CRYSTAL RIVER UNIT 3 NUCLEAR GENERATING PLANT

AMENDMENT TO FACILITY OPERATING LICENSE

Amendment No. 68
License No. DPR-72

ATTACHMENT TO LICENSE AMENDMENT NO. 68

FIGURE 3.4-5

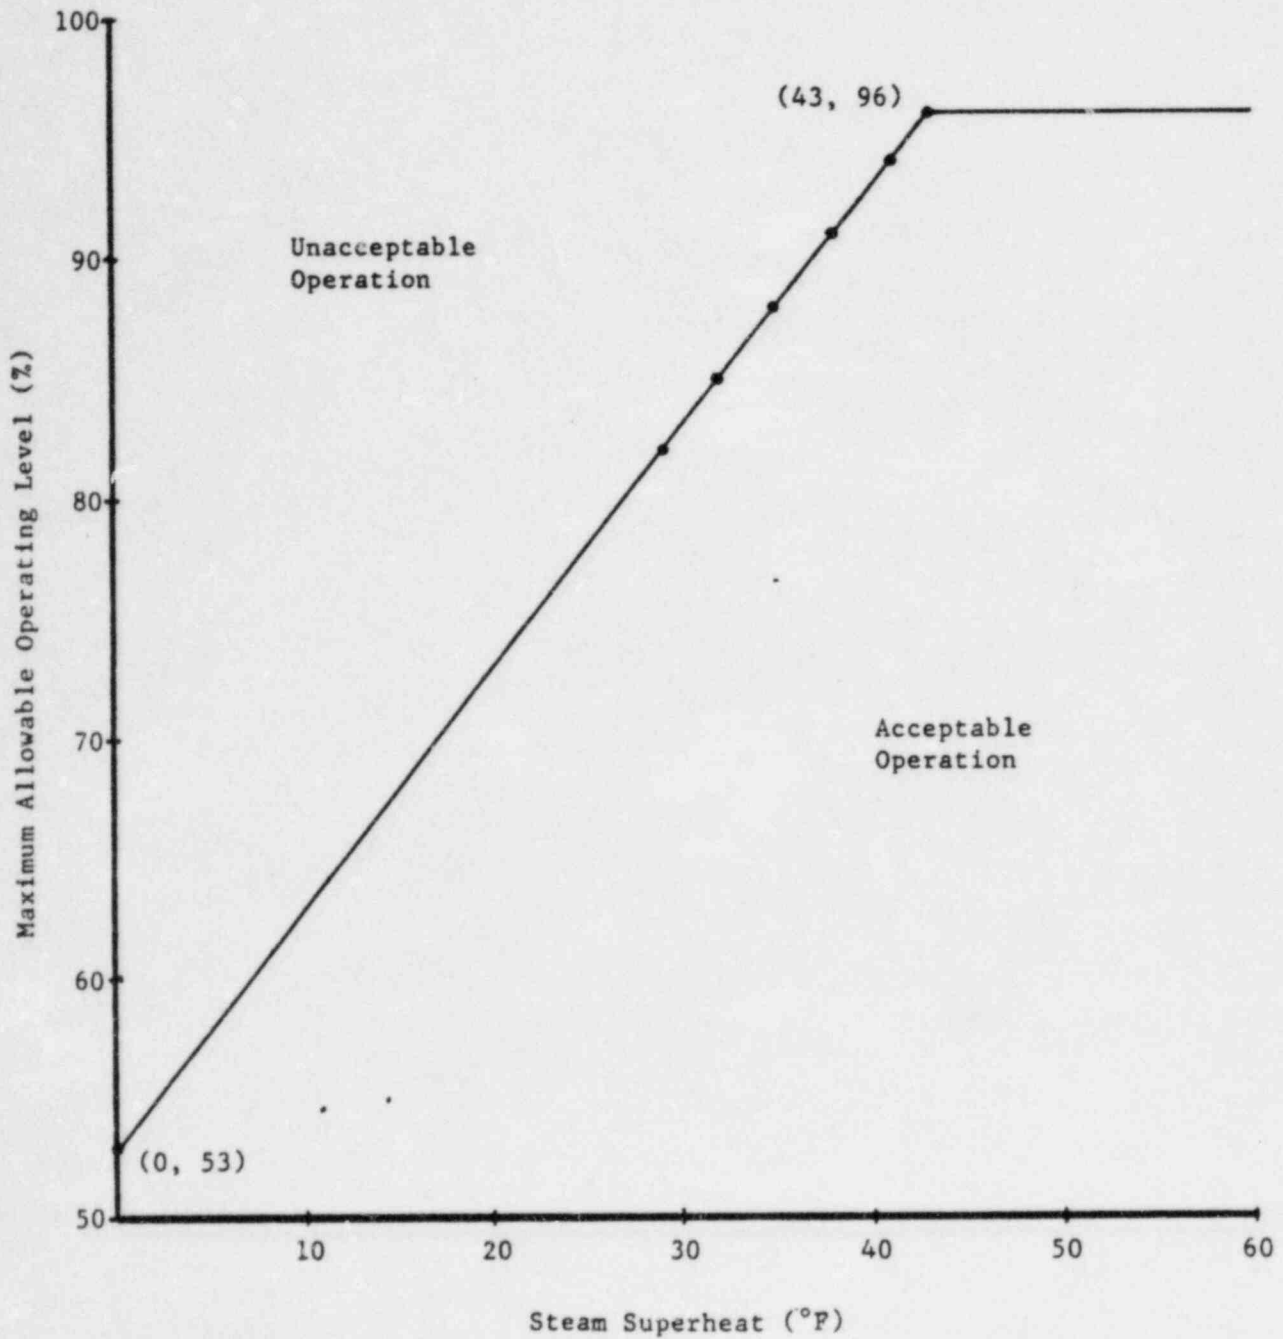
3.4.5 Each steam generator shall be OPERABLE with a maximum water level as specified on Figure 3.4-5 and a minimum water level of 18 inches.

*As noted on Figure 3.4-5, maximum water level restrictions are not applicable in MODE 4.

*Not applicable to Mode 4 operation.

The steam generator water level limits are consistent with the initial condition assumptions in the FSAR. The maximum steam generator level, as a function of steam superheat, is sufficient to assure a mass inventory of less than or equal to 62,600 lbm in the event of a main stream line rupture.
